ADDENDUM NO. 6
TO GENERAL, MECHANICAL AND ELECTRICAL
ABERDEEN PUBLIC WORKS
MAINTENANCE BUILDING
ABERDEEN, SOUTH DAKOTA

Addendum Dated: March 27, 2026

Original Plans and Specifications Dated: February 20, 2026

1 FIRST FLOOR HVAC VENTILATION PLAN - AREA E - ALTERNATE #2
1/8" = 1'-0"

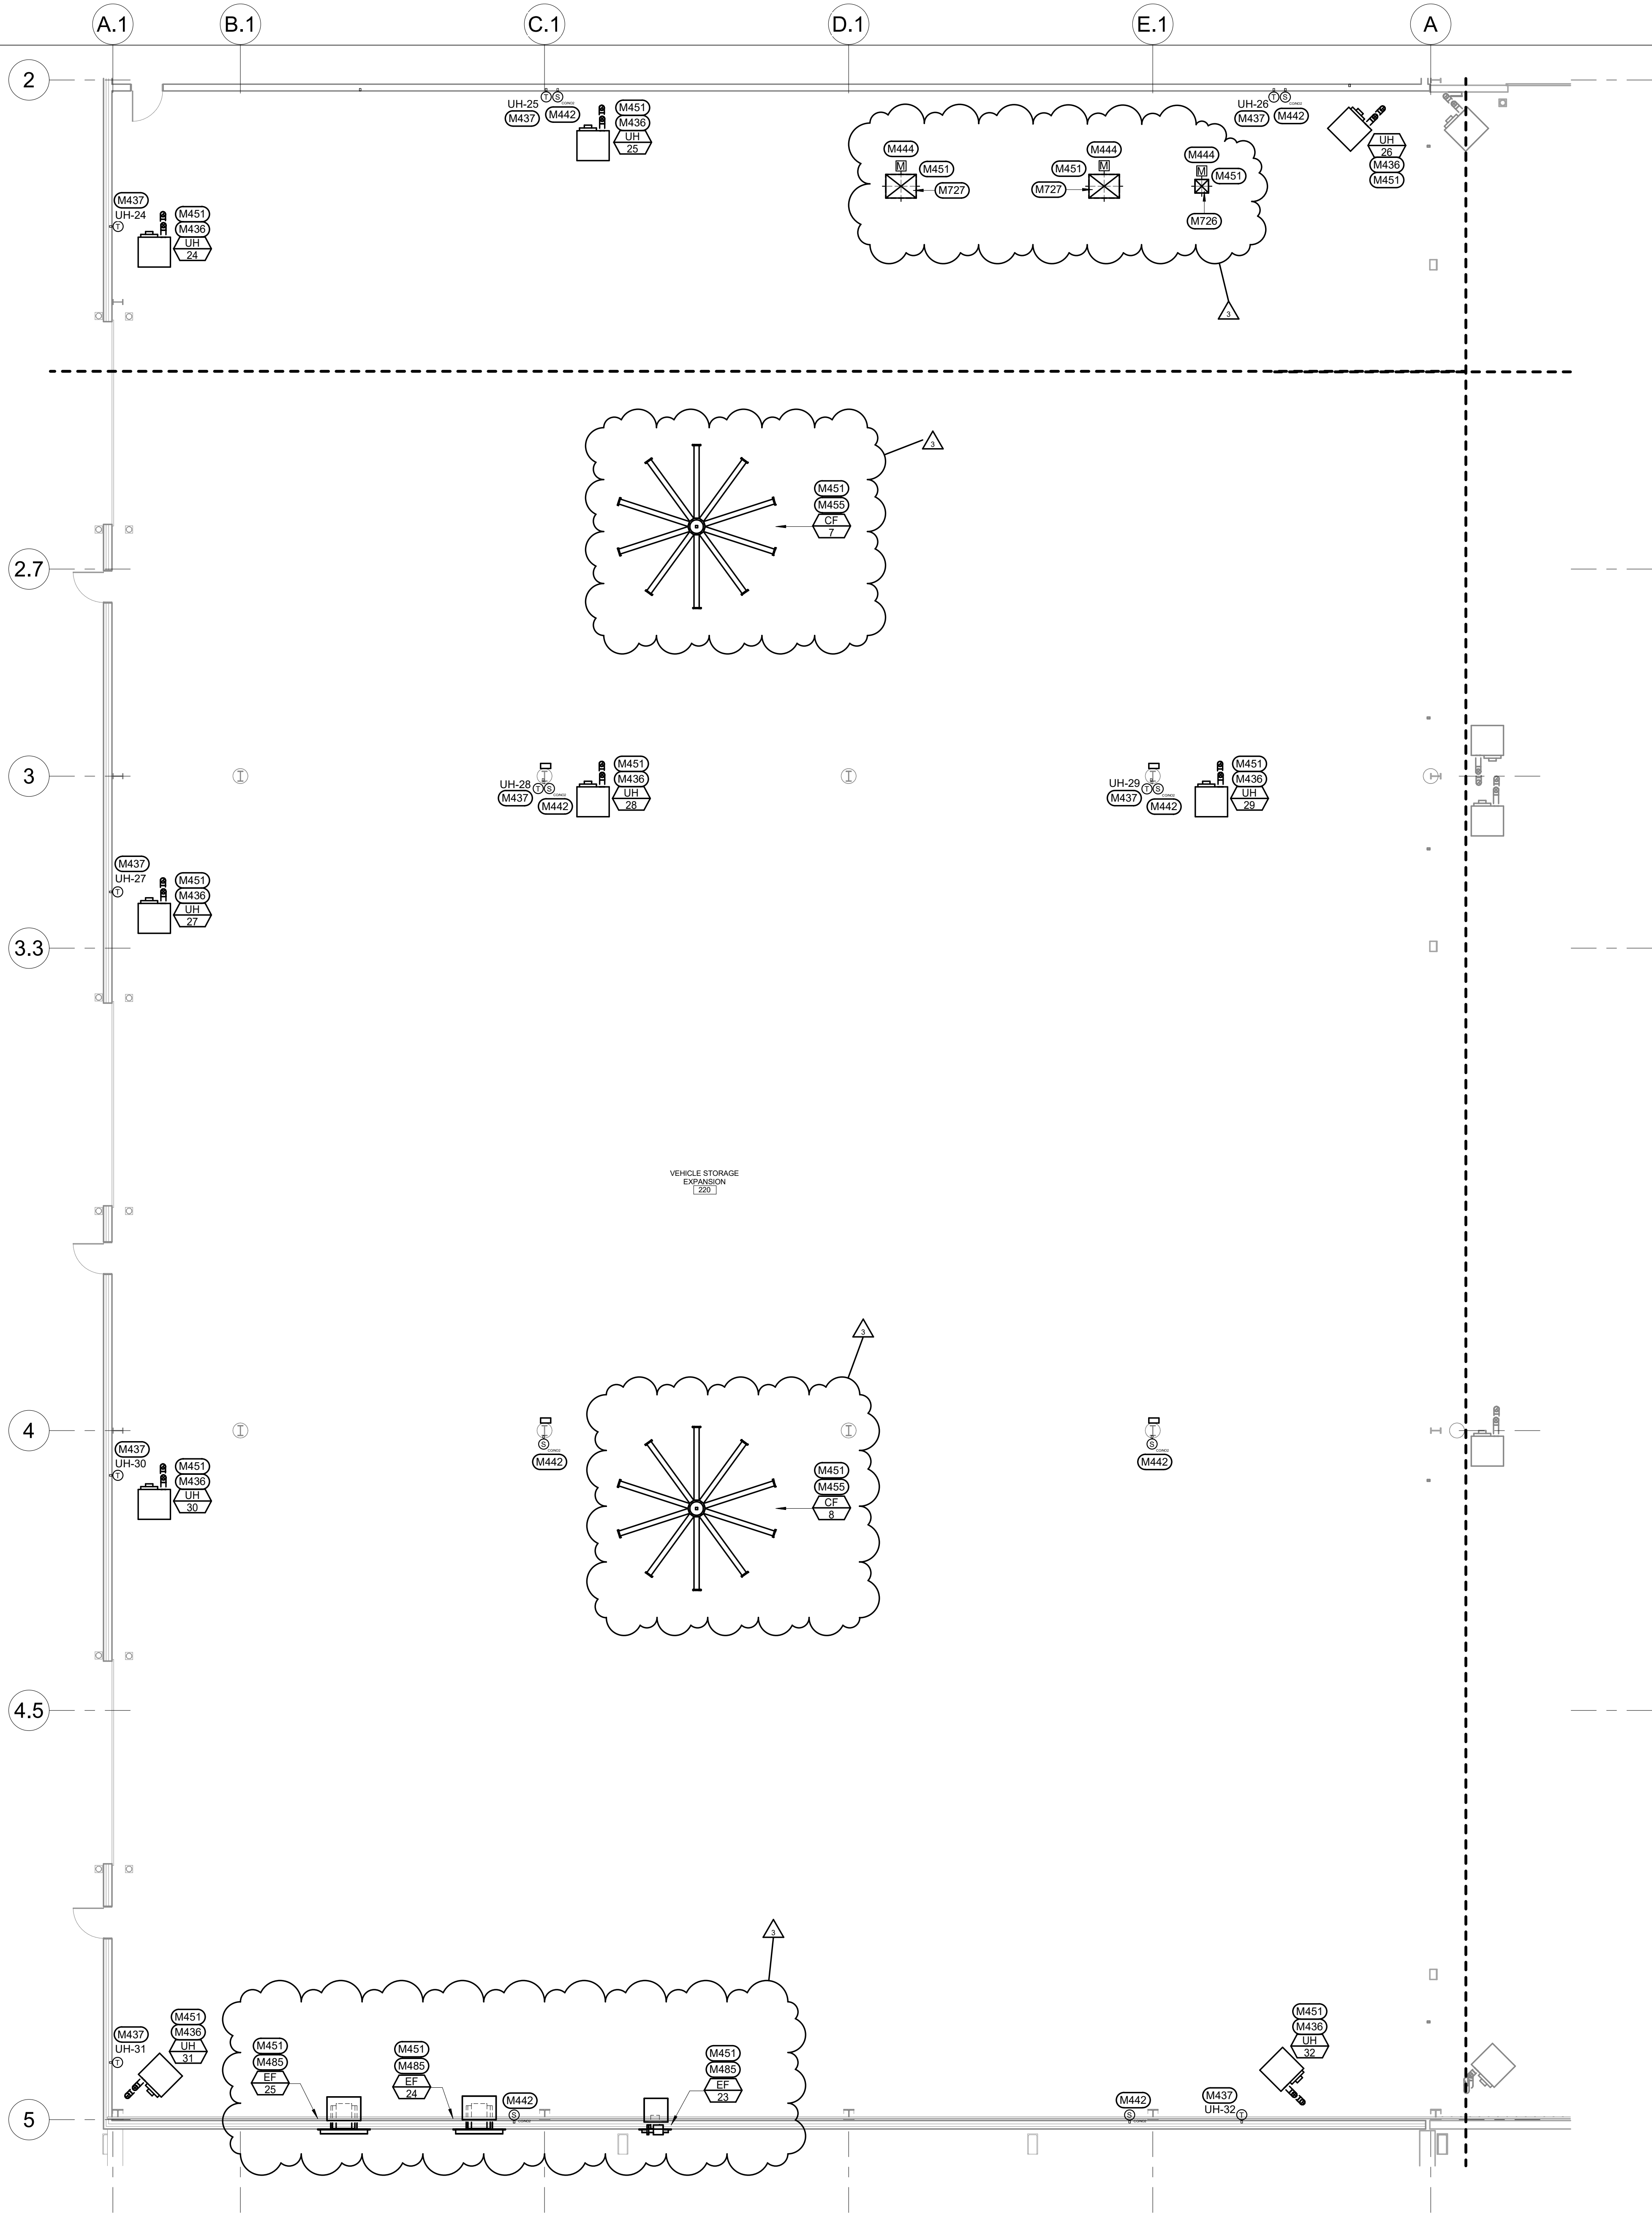
1. See attached sheet for the following revisions:
 - a. Intake hood ductwork added to the scope.
 - b. High Volume Low Speed (HVLS) fans were added to the scope.
 - c. Notes added to the drawing to better clarify the drawings intent.

1 FIRST FLOOR POWER PLAN - AREA A
1/8" = 1'-0"

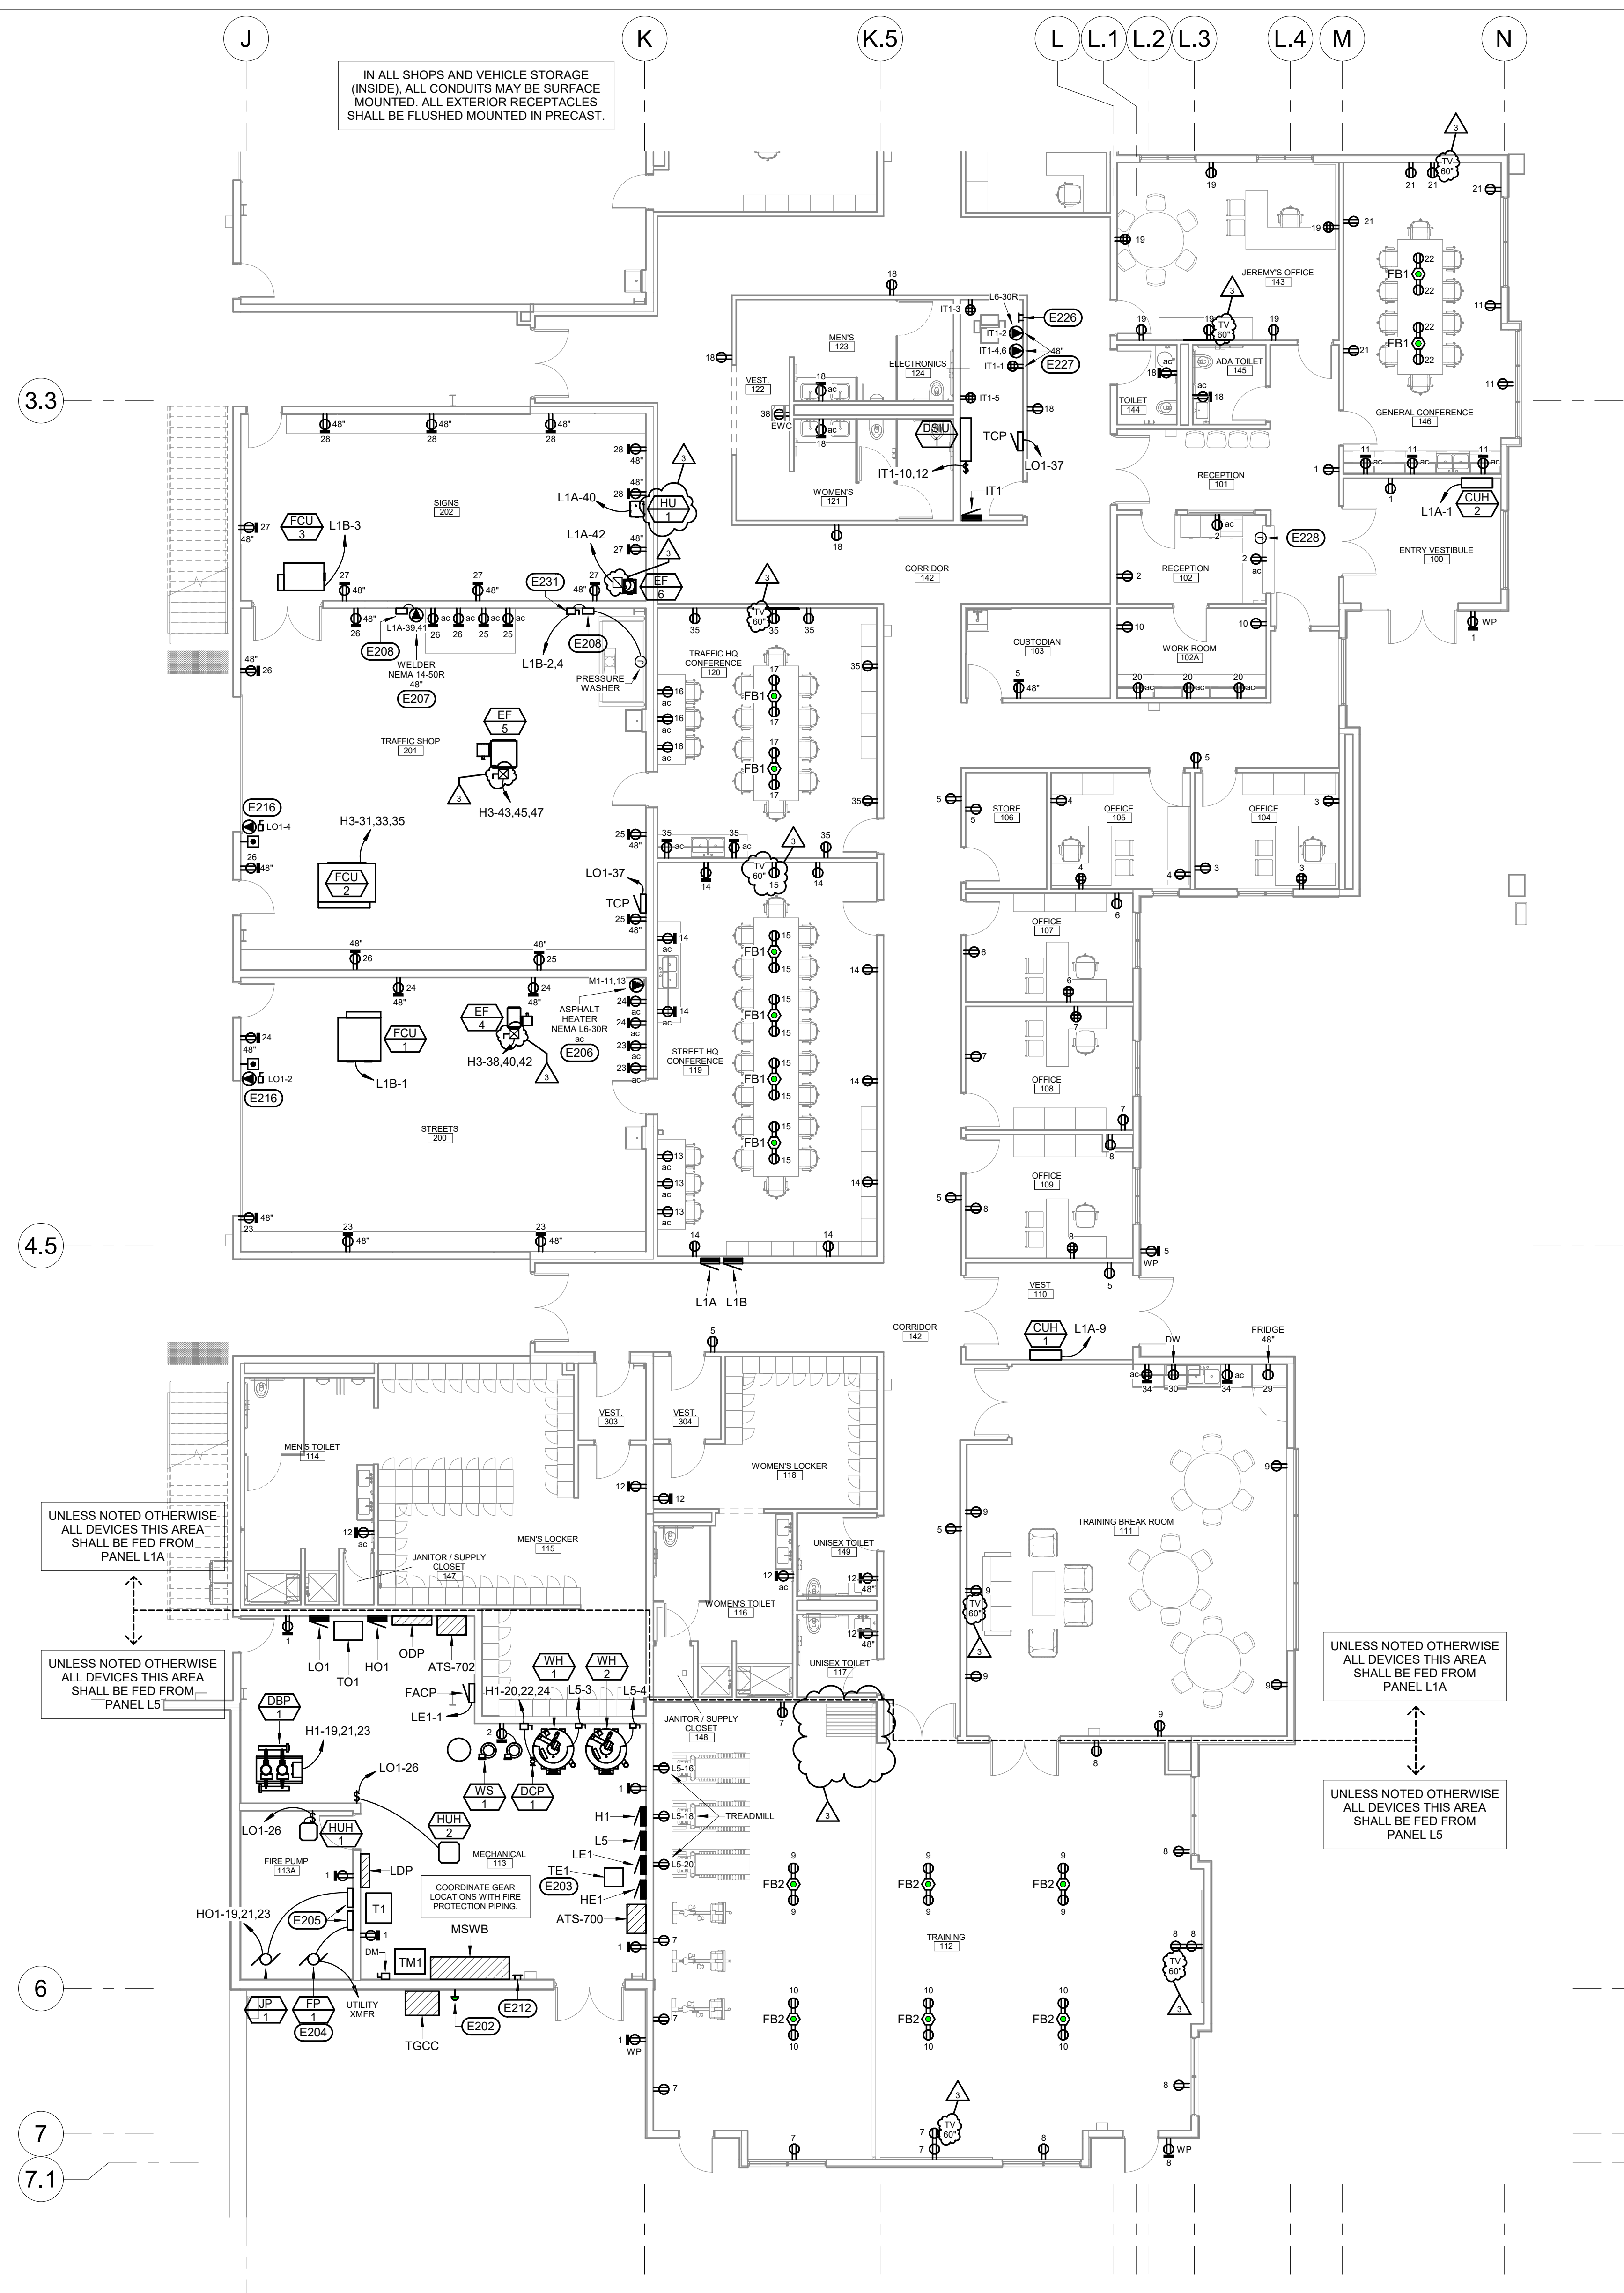
1. See attached sheet for the following revisions:
 - a. Removed circuit for motorized operable panel in TRAINING 112. This will be manually operated.
 - b. Added TV receptacles in STREET HQ CONFERENCE 119 and revised the height of other TV receptacles.
 - c. Updated mark for humidifier from H-1 to HU-1.
 - d. Added motor starters to various exhaust fans.

1 FIRST FLOOR POWER PLAN - AREA B
1/8" = 1'-0"

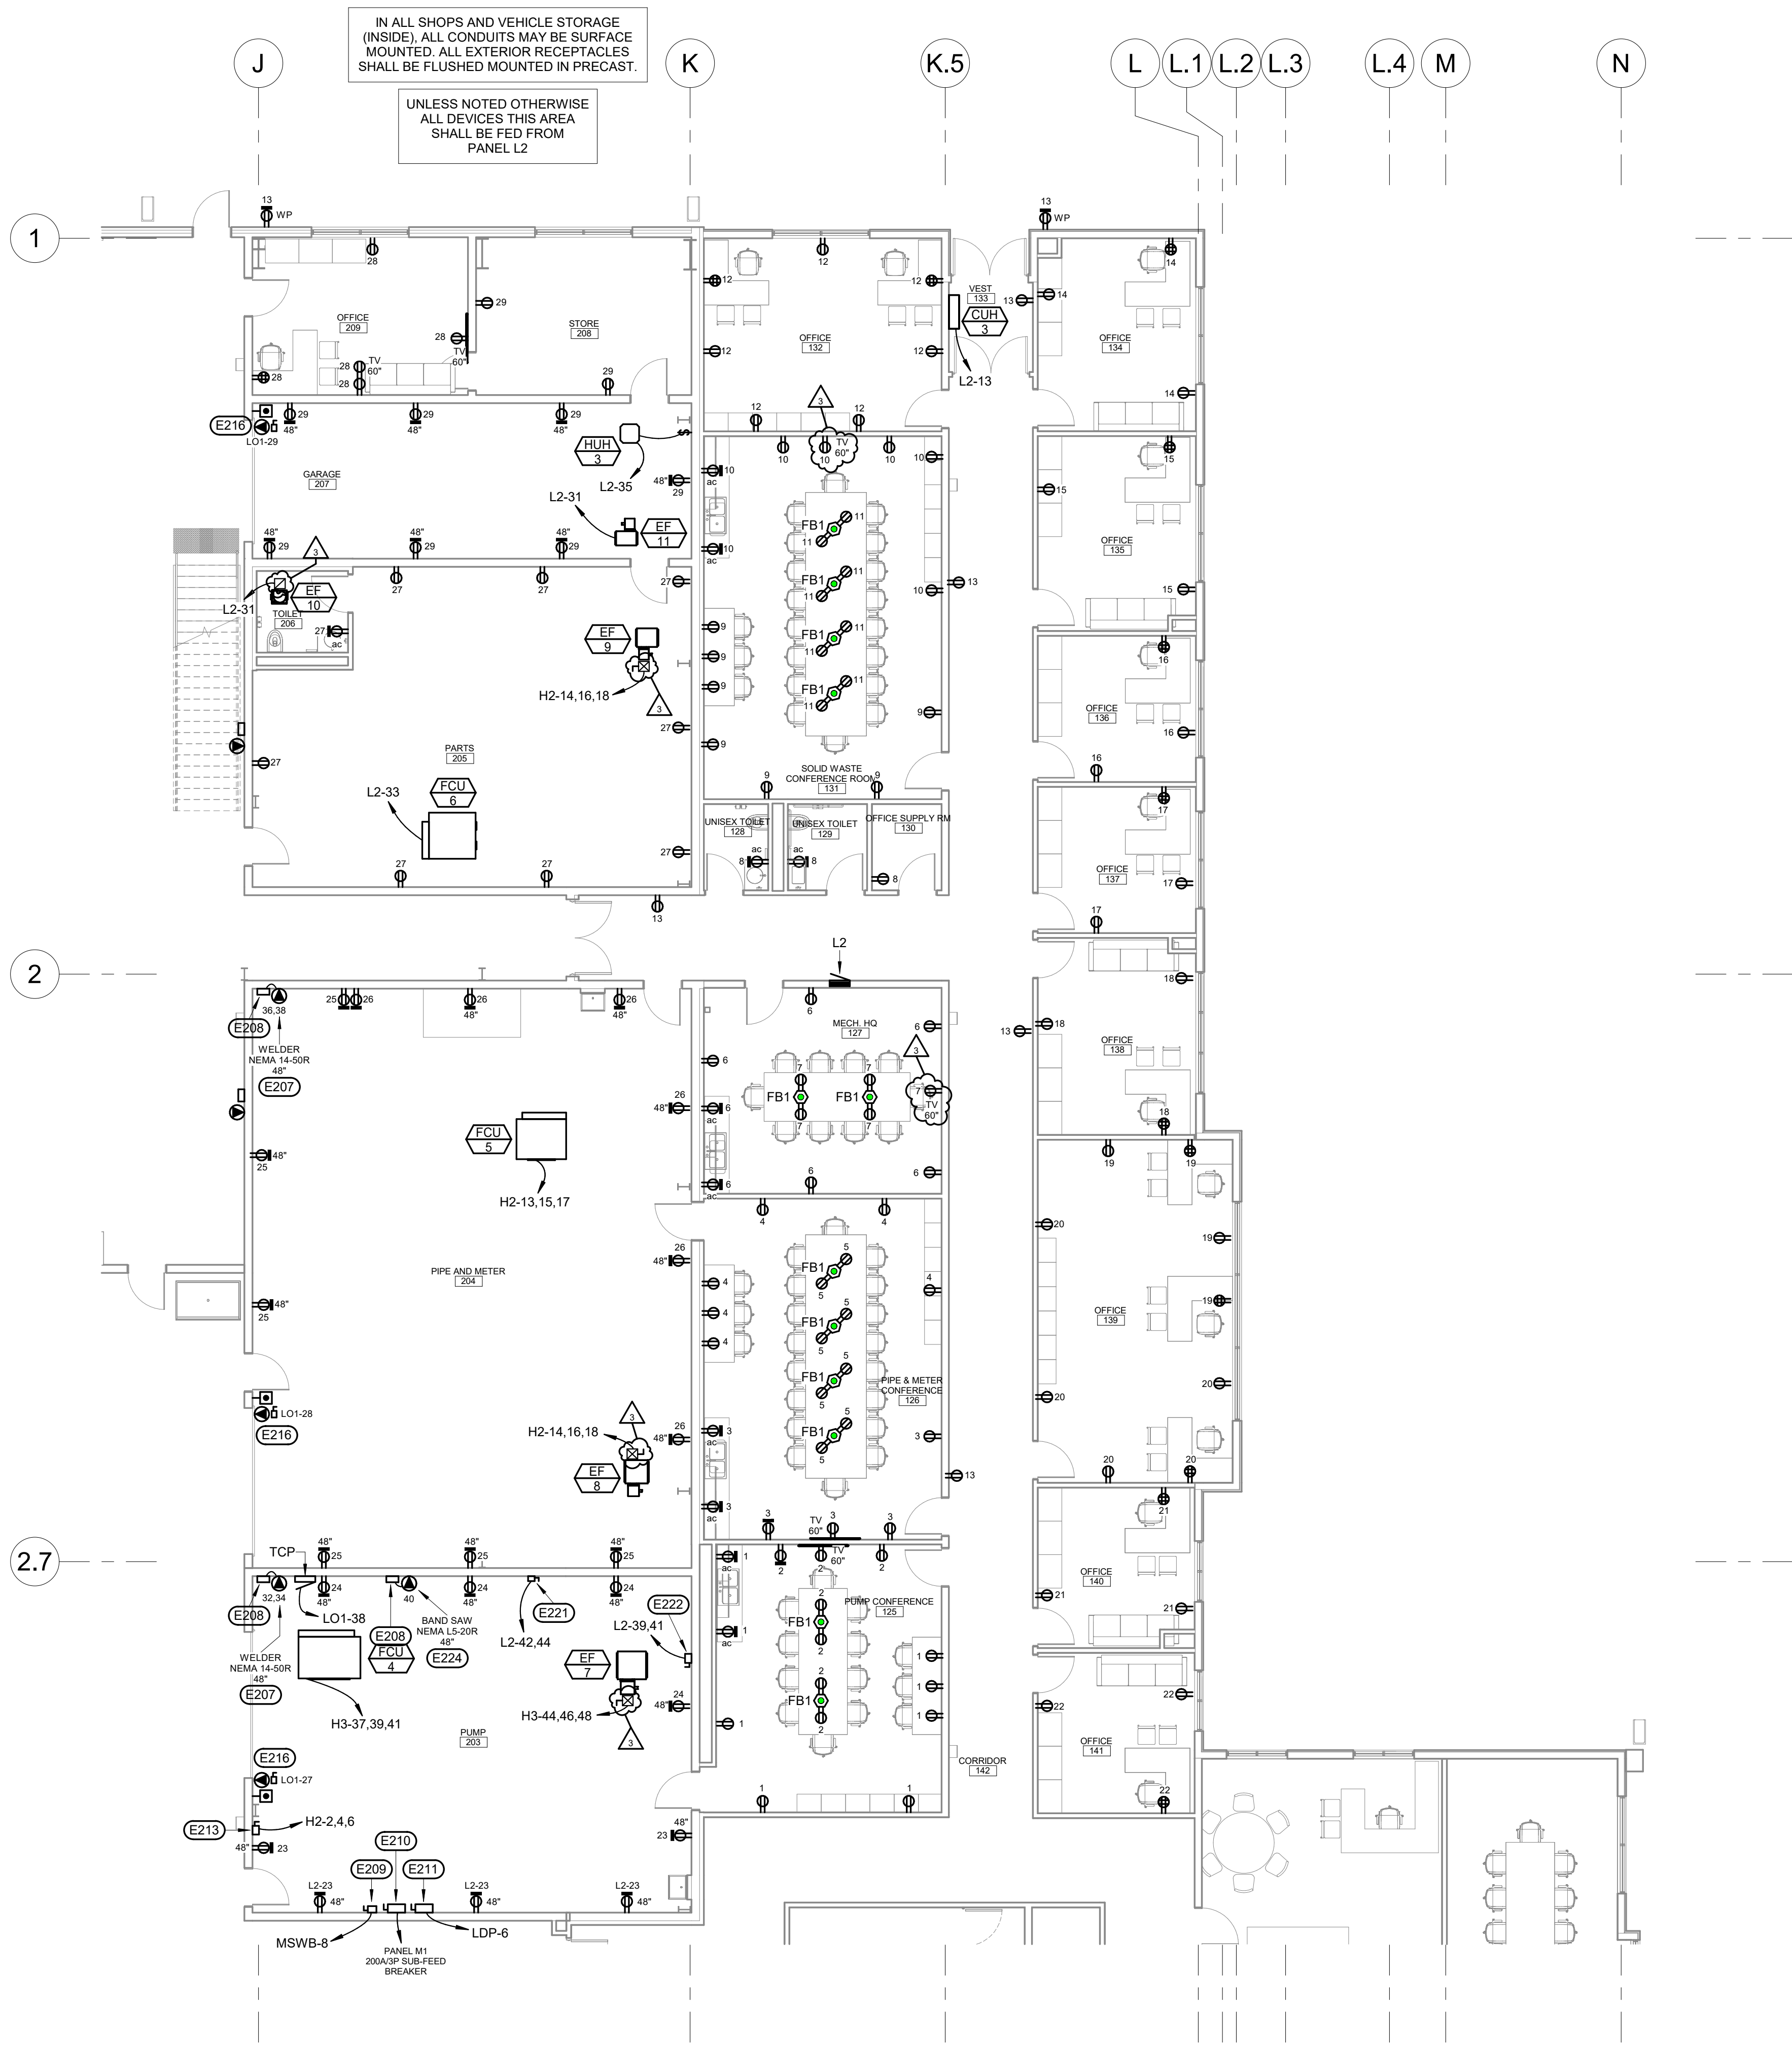
1. See attached sheet for the following revisions:
 - a. Added TV receptacles in MECH HQ 127 and SOLID WASTE CONFERENCE ROOM 131.
 - b. Added motor starters to various exhaust fans.
